FINAL DRAWING

GENERAL DIMENSION UNLESS OTHERWISE STATED ACCORDING TO DIN 7168		DESCRIPTION:	
CLASS		Towelrack	
NOMINAL MEASUREMENTS (mm)		ARTICLE NR. (packed product): 1313630946 (for packaging information see GDS)	
0.5 UNTIL 3	3 UNTIL 6	6 UNTIL 30	30 UNTIL 120
±0.1	±0.1	±0.2	±0.3
120 UNTIL 400	400 UNTIL 1000	1000 UNTIL 2000	2000 UNTIL 4000
±0.5	±0.8	±1.2	±2
PROJECTION:	GENERAL ANGLE:	VERSION NAME:	ARTICLE NR. (packed product):
	±0,5°	stainless steel	1313630946
DRAWN BY:	MS	GENERAL ROUGHNESS:	PROJECT:
CHECKED BY:		0,8	205-Colar
DATE:	29-7-2015	UNITS:	DRAWING NR.:
STATUS:	Production	mm	205.09.00.TS
PRINT DATE:	14-4-2026	SCALE:	 Tiger Products b.v. Winde 3, PO box 11 5660 AA Geldrop The Netherlands
INT.REV.NR.:	01	1:2	
		FORMAT:	
		A3	
		SHEET:	
		1/3

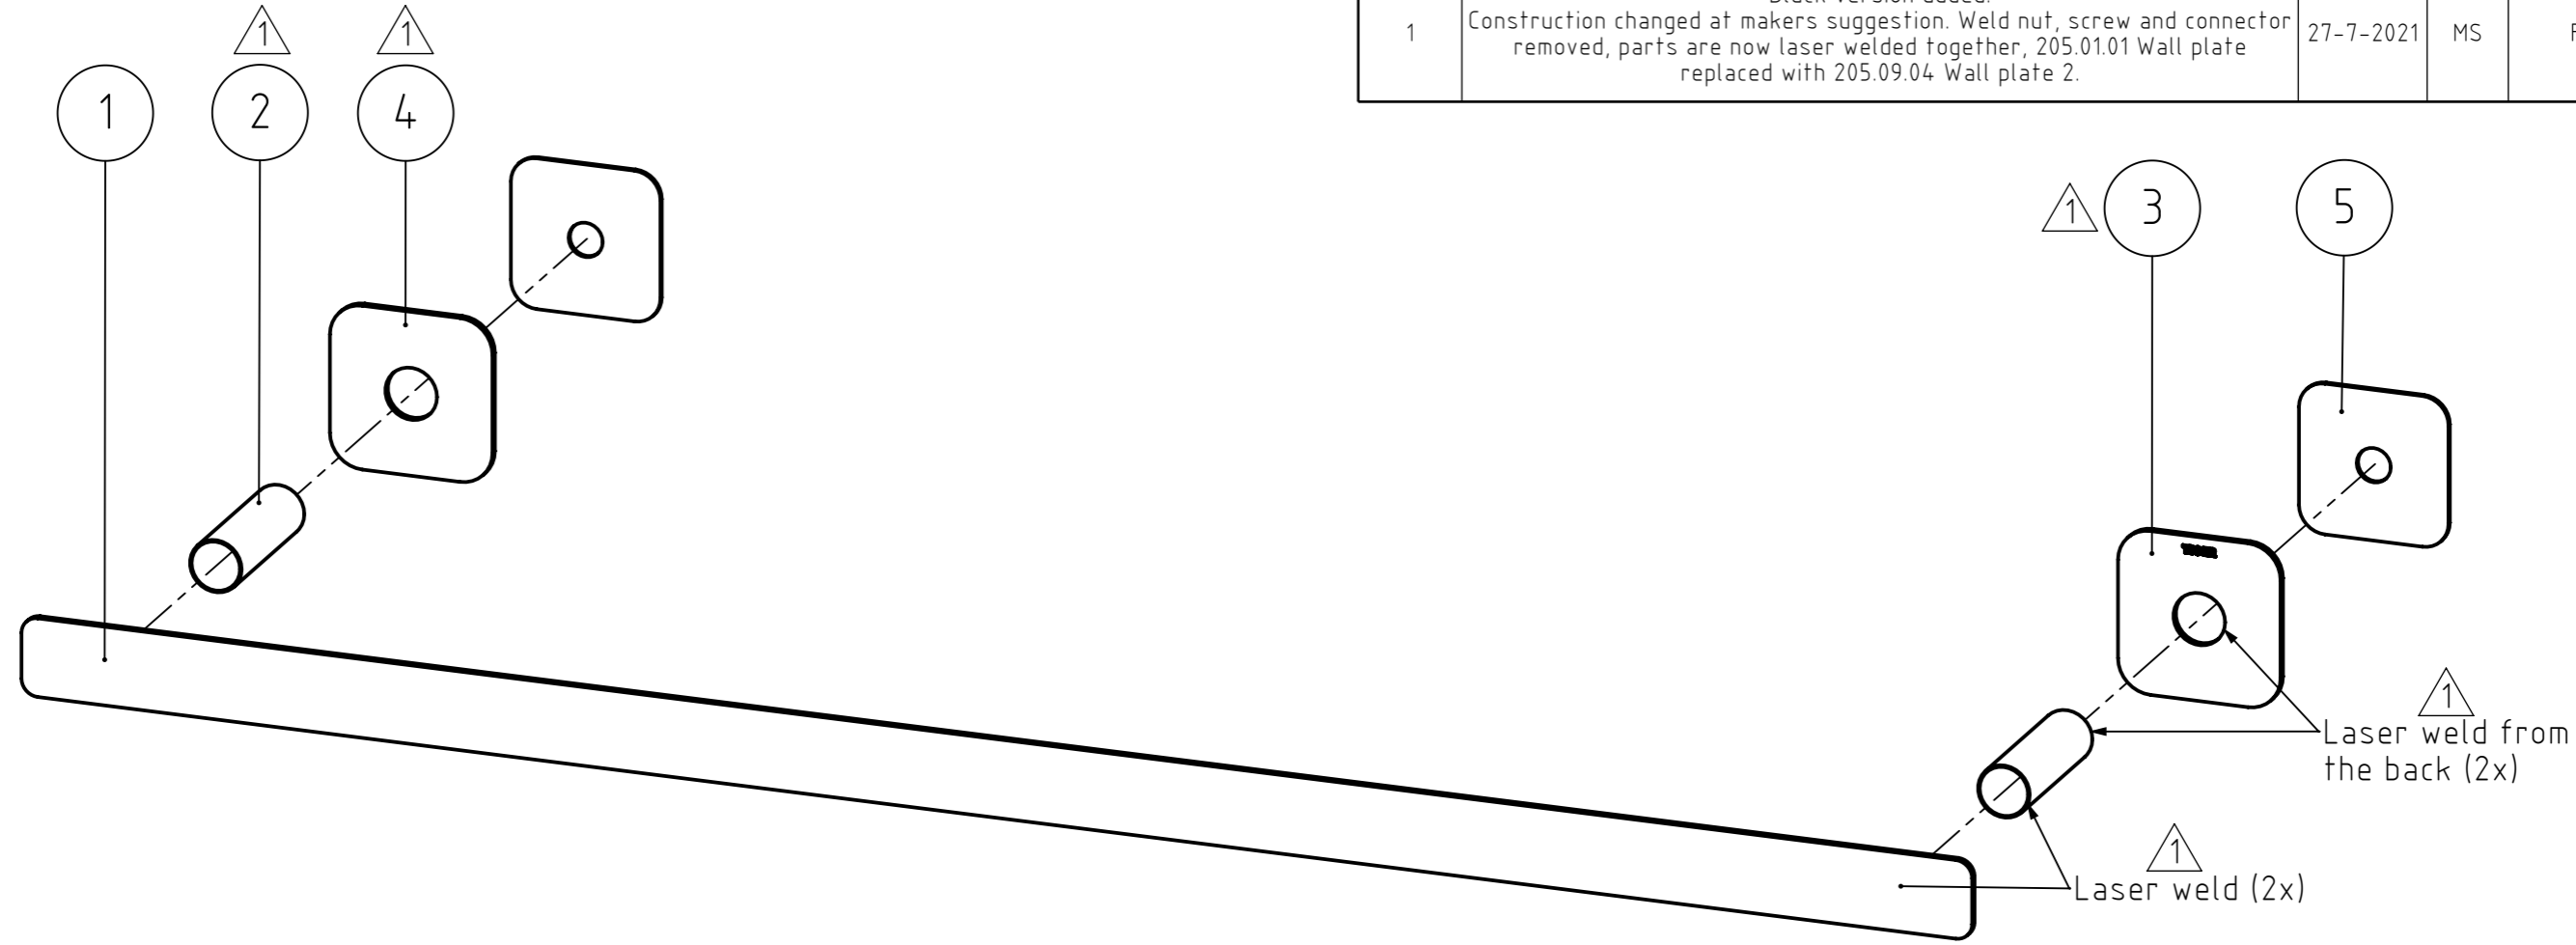
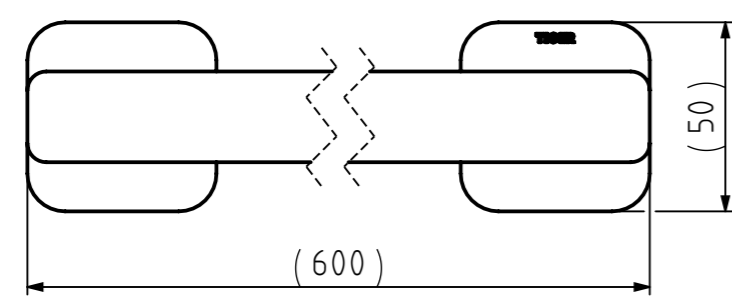
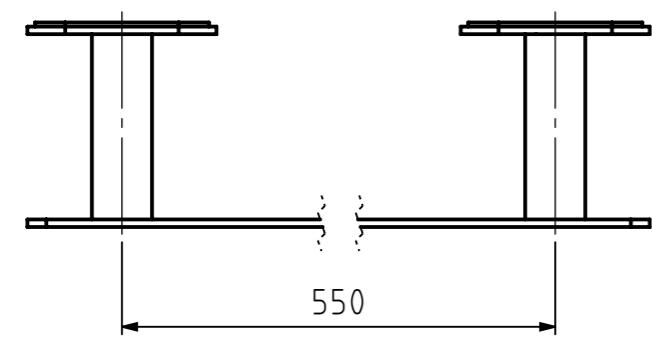
REVISIONS				
REV.	DESCRIPTION	DATE	BY	APPROVED
1	Black version added. Construction changed at makers suggestion. Weld nut, screw and connector removed, parts are now laser welded together, 205.01.01 Wall plate replaced with 205.09.04 Wall plate 2.	27-7-2021	MS	FvP
